COMBS PLACE SUBDIVISION, **RESUBDIVISION OF LOT 2**

APPLICATION NUMBER 2 DATE Spetember 16, 2010

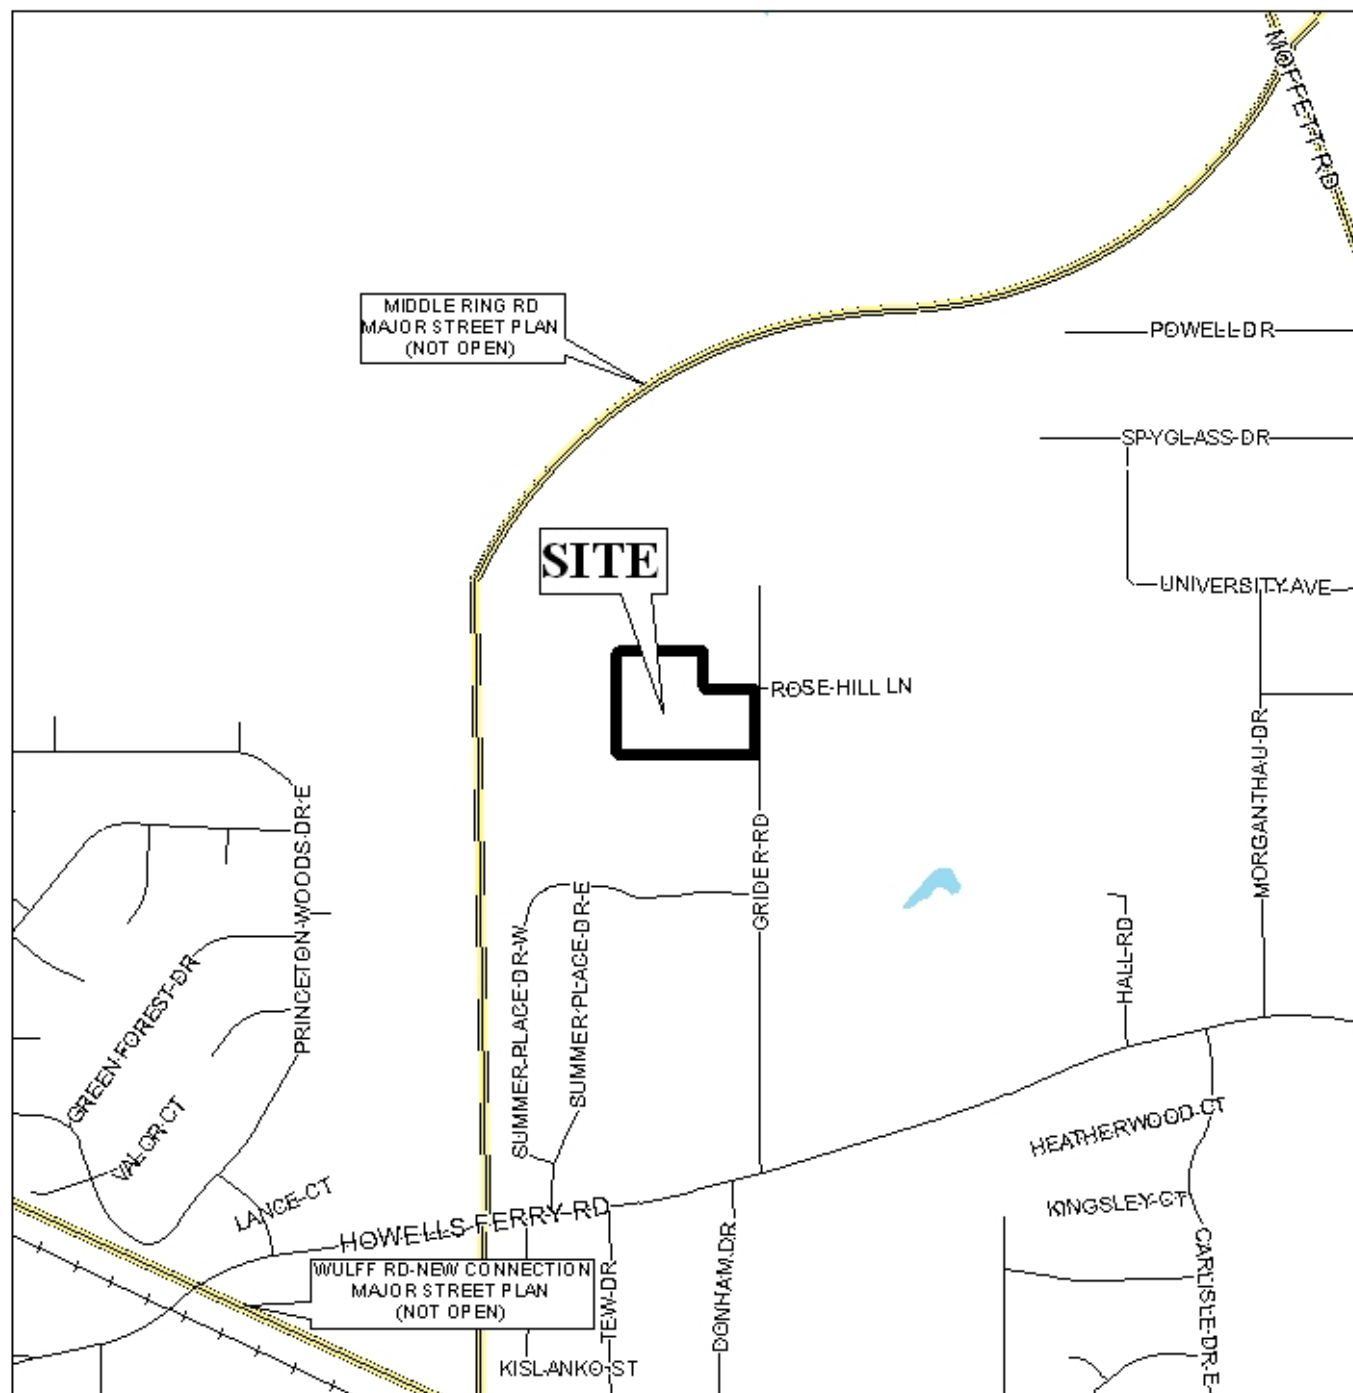
As proposed, the subdivision will create two lots with each meeting the minimum size requirements of the Subdivision Regulations. The lots are labeled on the plat with their sizes in acres. The plat should be revised to label the lots with their sizes in both acres and square feet, or a table should be furnished on the final plat providing the same information.

Both lots would exceed the maximum depth-to-width ratio allowed by Section V.D.3. of the Subdivision Regulations; however, such lots are typical of the immediate area and a waiver of that section would be in order. Also, proposed Lot 2 would be a flag lot; however, it would be the modification of a previously approved flag lot. A waiver of Section V.D.1. of the Subdivision Regulations would be in order. Combs Place Subdivision was basically a resubdivision of Lots 2, 3 and 4, Grider Hills Subdivision, which was given final Commission approval in June, 1971. Proposed Lot 3 would simply be the re-establishment of the same boundary lines as Lot 4, Grider Hills Subdivision.

With a waiver of Sections V.D.1. and V.D.3. of the Subdivision Regulations, the plat meets the minimum requirements and is recommended for tentative approval, subject to the following conditions:

- 1) Illustration of the 25' minimum building setback line along Grider Road;
- 2) placement of a note on the final plat stating that each lot is limited to one curb cut to Grider Road, with the size, location, and design to be approved by Traffic Engineering and conform to AASHTO standards;

- 3) revision of the plat to label each lot with its size in both acres and square feet, or the furnishing of a table on the final plat providing the same information;

- 4) placement of a note on the plat stating that approval of all applicable Federal, state and local agencies is required for endangered, threatened or otherwise protected species, prior to the issuance of any permits or land disturbance activities;

- 5) subject to the Urban Forestry comments: *(Property to be developed in compliance with state and local laws that pertain to tree preservation and protection on both city and private properties [State Act 61-929 and City Code Chapters 57 and 64]. Preservation status is to be given to the 35" Live Oak Tree located on the North side of proposed Lot 2. Any work on or under this tree is to be permitted and coordinated with Urban Forestry; removal to be permitted only in the case of disease or impending danger); and*

- 6) subject to the Engineering comments: *(Detention will be required for Lots 2 & 3, the detention shall detain the 100 year storm event, with a 2 year release rate onto the downhill properties. Must comply with all storm water and flood control ordinances. Any work performed in the right of way will require a right of way permit).*
